Product Change Notification: CENO-12ILED699

CCB 6730 Final Notice: Qualification of ASEM as an additional assembly site for selected KSZ8863 device family available in 48L LQFP (7x7x1.4mm) package.

CCB 6730
Pre and Post Change Summary
PCN #: CENO-12ILED699

QUALIFICATION REPORT SUMMARY

LEAD FRAME COMPARISON

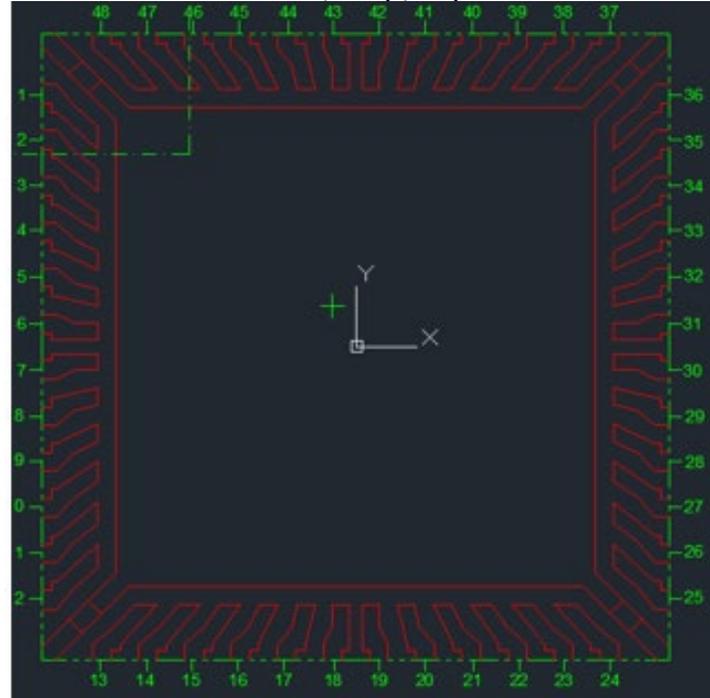
ASE

Lead frame Material	C7025
Paddle size	197X197 mils
Lead-Lock	No

OSE

Lead frame Material	C7025
Paddle size	205X205 mils
Lead-Lock	Yes

ASEM

Lead frame Material	C7025
Paddle size	205X205 mils
Lead-Lock	No
